Subject: Response to AFCD Submission

Proposed Temporary Holiday Camp, Place of Recreation, Sports or
Culture (Hobby Farm), Field Study/Education/Visitor Centre, and
Public Vehicle Park (excluding Container Vehicle) for a period of 3 years
in “Village Type Development”, “Recreation (1)”, and the areas are
shown as ‘Road’ of various Lots in D.D 41 and the adjoining
Government Land, Sha Tau Kok, New Territories.

**Response to the Agriculture, Fisheries and Conservation Department
(AFCD)**

Drawing No:
03 B

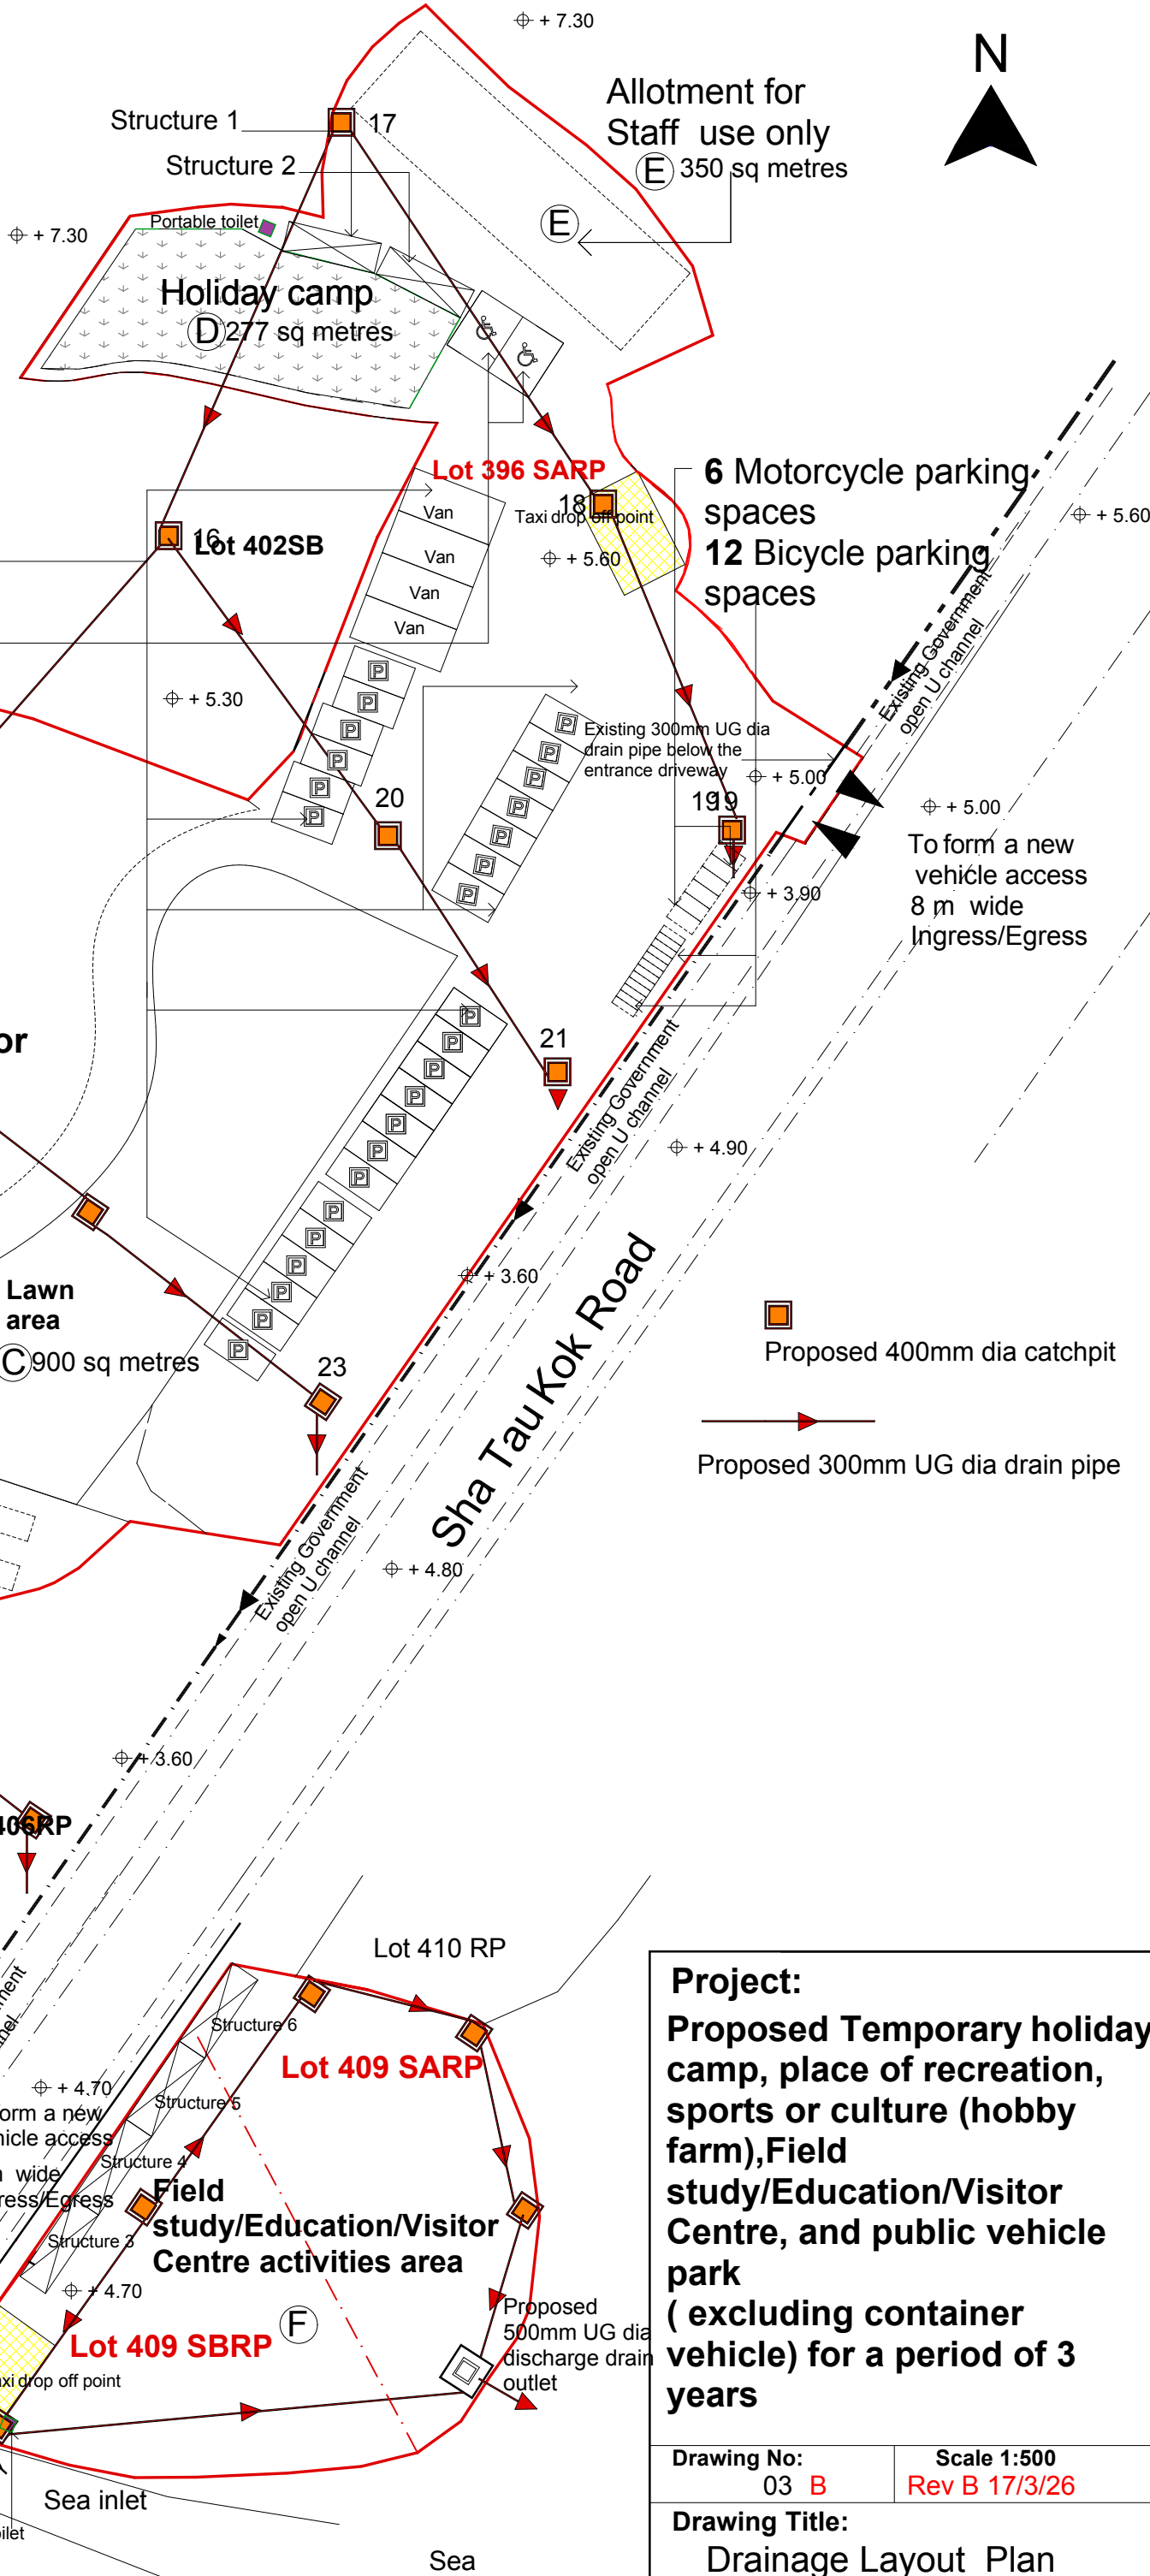
- (a) The applicant should elaborate on what measures will be implemented to avoid adverse impacts on the surrounding environment, including nearby trees, watercourses and mangroves as far as practicable; and
- (b) The applicant should consider relocating the proposed structures (e.g. Structures 3 to 6) away from the above-mentioned ecological resources, preserving trees within the application site as well as providing hoardings, screen planting and/or boundary wall.

However, to avoid the site surface water flooding onto the watercourse, the Application Site will be equipped with catch pits connected to an underground 300mm diameter double-wall corrugated sewage pipe (HDPE). The pipe layout will follow the existing flow path with a fall not less than 1:100, then connect to the existing 600mm Government (HAD) open U-channel, as demonstrated by the attached proposed Drainage Plan 03B.

Appendix 1

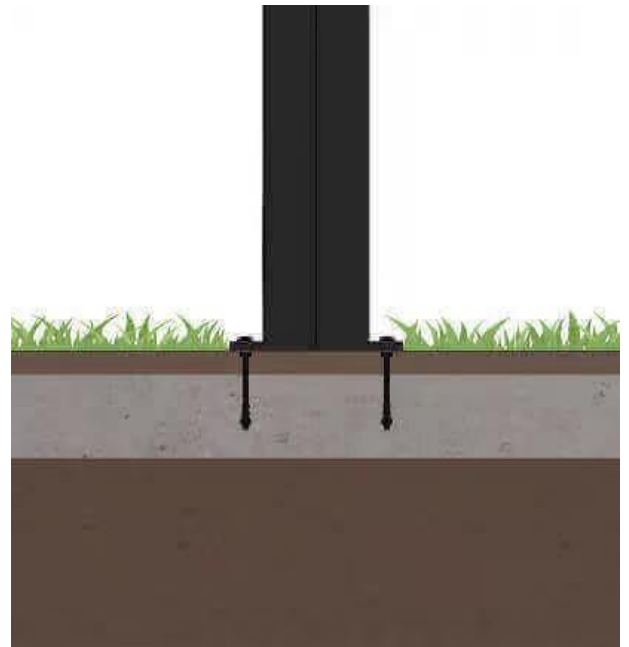
Please advise the installation method of the 2 metre high metal profile hoarding along the drip line of tree crown and 1.2 metre high metal rail 900 mm from and along the tree trunk at Tree T4 and T5 and whether excavation work will be required for the installation. In general, all trenches should be at least 1.5 m away from any tree within 250 mm Diameter at Breast Height (DBH) or at least 6 times the DBH of any tree if their DBH exceeds 250 mm. Any excavation within 2.5 m or falls within the drip line of a tree must be done by hand and that no roots of 25 mm dia. or above may be severed. The applicant should also observe to “Tree Care during Construction” issued by Tree Management Office during planning stage and the whole course of the work.

The 1.2 metres and 2 metres site temporary hoarding and metal rail mesh fence panels are either fixed with a solid, heavy-duty rubber foot locking block or freestanding; no excavation work is required for these erections. Please see photos of Fences in Appendix 1.

The proposed 1.8m L x 1.8m H new fencing system is fixed and supported by two surface-mounted fence posts. A shallow concrete footing, approximately 0.2m in width x 0.25m in Depth, is required. Please see photo of surface-mounted fixing in Appendix 1.
